Project	Proposed Solar Farm and BESS – Land off Main Road, Kelham, Nottinghamshire	Document No	153626-005-03
Subject	Technical Note – Response to Consultation Responses from Nottinghamshire County Council Highways and National Highways

Overview

Nottinghamshire County Council Highways Consultation Response 31/10/2023

Figure 3 – 5-year Road Traffic Collision Record

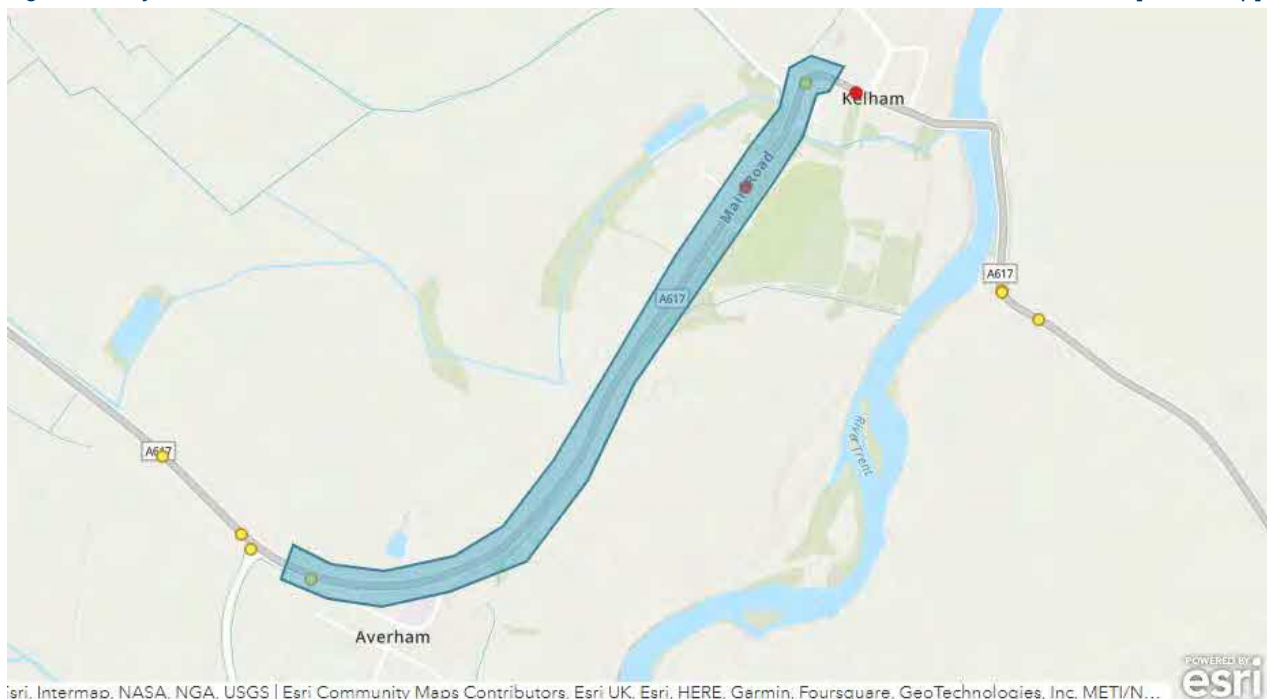
- Provide swept path analysis of bends on A617
- Update accident analysis to include 2022 data and 2023 where possible

The incident data is provided for the period January 2017 to the end of December 2021, including periods during lockdowns. The applicant should determine whether data is available during 2022 and 2023 and update the analysis as appropriate.

The Crashmap database has been investigated and 2022 data is now available, therefore the analysis has been updated as follows.

The assessment shows that three accidents (1 ‘serious’ and 2 ‘slight’ in nature) have occurred in the study area over the five-year period. The full reports can be viewed at Appendix D, and a summary of the incidents is as follows:

Given the busy nature of the A617, (Annual Average Daily Flow of 15196 (2018), recorded to the west of the site), three accidents occurring within a five-year period does not allude to a deficiency within the highway network. The accidents occurred due to driver error and therefore, during the construction phase of the solar farm and BESS site, the accidents are not likely to be exacerbated.

Client	Sirius Planning Ltd			
Project Title	Main Road, Kelham, Newark-on-Trent			
Drawing Title	Proposed Access Design with Max Legal Length HGV Vehicle Tracking			
Scale	1:200	Drawn By	LY	
Drawing Size	A2	Checked By	KS	
Date	June 2023	Approved By	KS	
Drawing Number	153626-001			Rev C

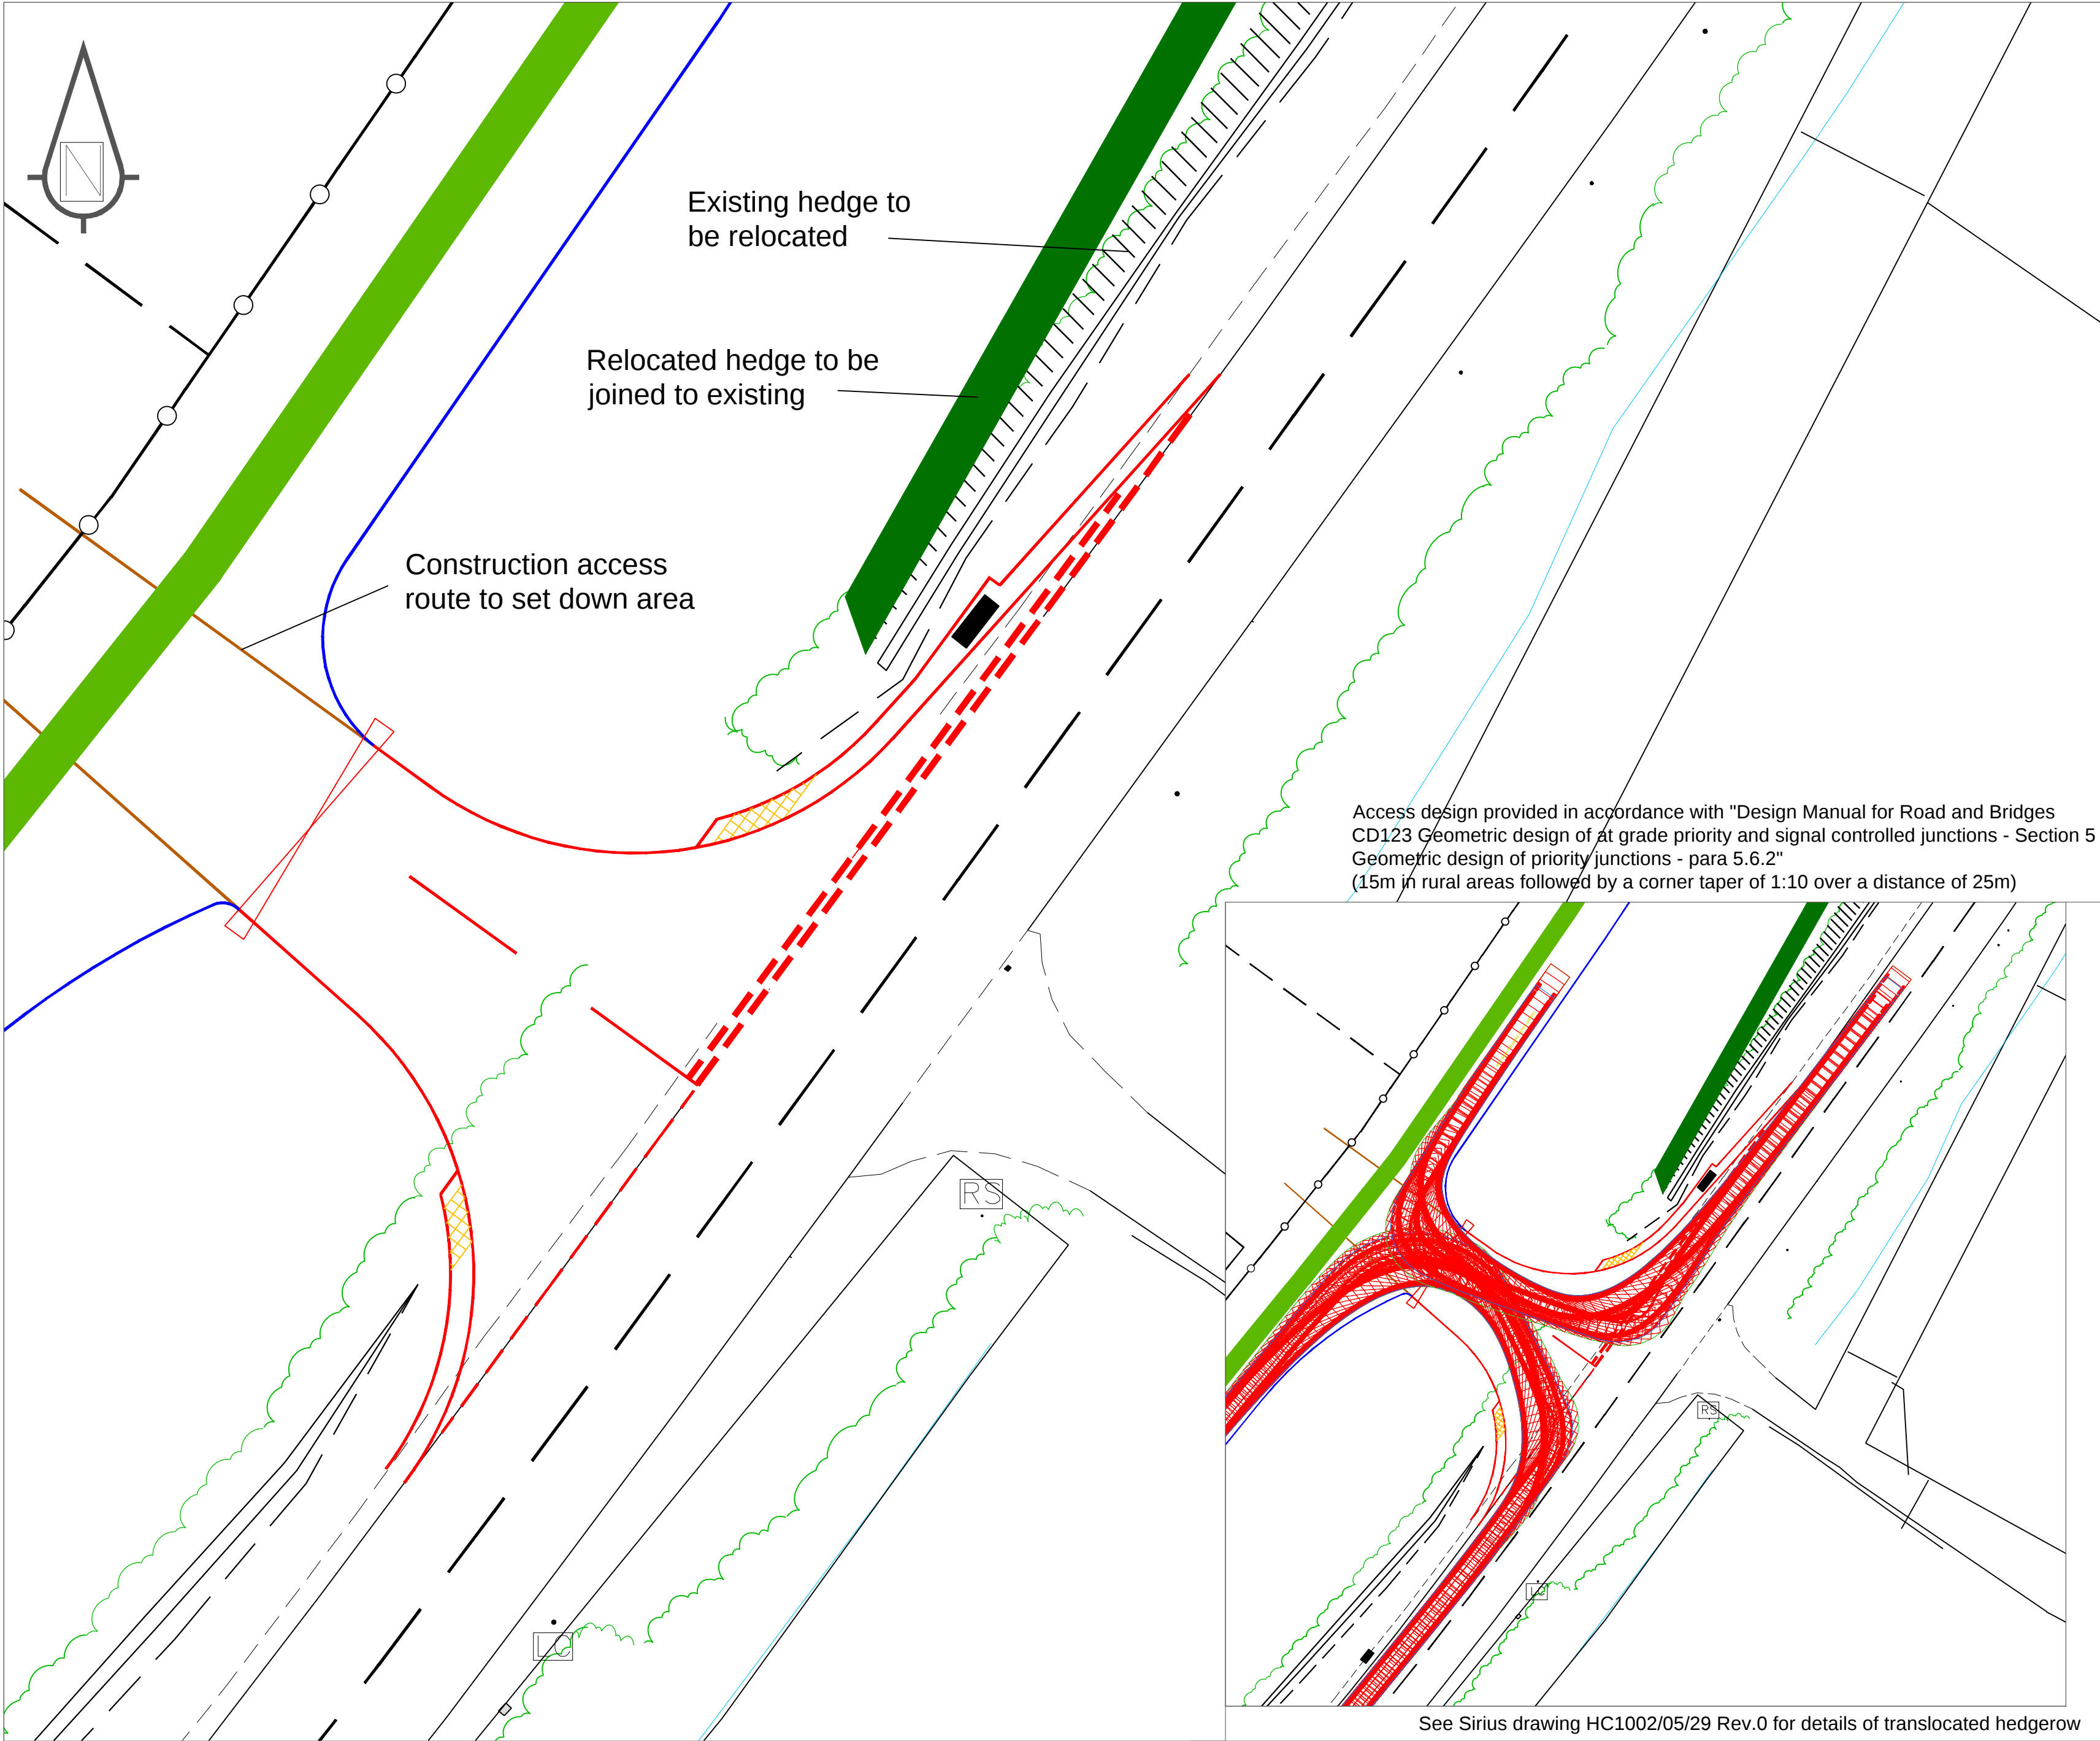
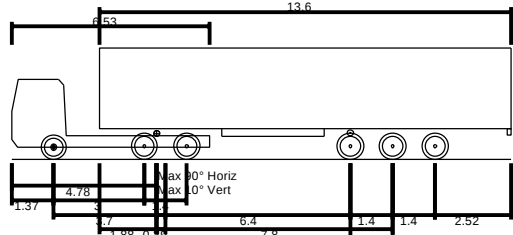
- As currently shown, the proposed site access geometry is not acceptable to the highway authority. It does not accord with the geometric requirements set out in the Design Manual for Roads and Bridges (DMRB) as it does not include the necessary corner taper on the entry into the site.
- Provide swept path analysis of 18.5m long articulated vehicles
- Consider access by abnormal loads
- Relocate gate to allow longer vehicles to wait clear of the access.
- Suggest stopping-up and reinstatement of access points other than main access.

As currently shown, the proposed site access geometry is not acceptable to the highway authority. It does not accord with the geometric requirements set out in the Design Manual for Roads and Bridges (DMRB) as it does not include the necessary corner taper on the entry into the site.

Drawing number 153626-001A shows swept paths for a 16.5m long articulated vehicle. In 2023, the maximum permissible length of an articulated HGV became 18.55m. Swept paths will be needed to show that the proposed access can accommodate such longer vehicles. Access by any abnormal loads will also have to be considered.

Sirius Planning drawing number HC1002/05/23 also illustrates access details, for which the above comments also apply. In addition, that drawing shows a proposed gate on the site access road located a short distance from the highway boundary. Any such gate will need to be set back to allow long vehicles to wait on the access clear of the highway. 30m is recommended to accommodate an abnormal load and escort vehicle. The site access road should be hard-surfaced over at least this distance.

Drawing 153626-001 Rev C, attached at **Appendix C**, has been prepared which sets out the revised access arrangement to the site from the A617. This arrangement incorporates the corner tapers as set out in CD123 (sections 5.5 and 5.6).

The drawing also demonstrates the swept path analysis of an 18.5m long articulated vehicle as requested.

Drawing 153626-001 Rev C shows a relocated gate position which will allow an 18.5m long articulated vehicle to enter the access and stand clear of the highway should the gate be closed upon arrival.

Access design provided in accordance with "Design Manual for Road and Bridges CD123 Geometric design of at grade priority and signal controlled junctions - Section 5 Geometric design of priority junctions - para 5.6.2" (15m in rural areas followed by a corner taper of 1:10 over a distance of 25m)
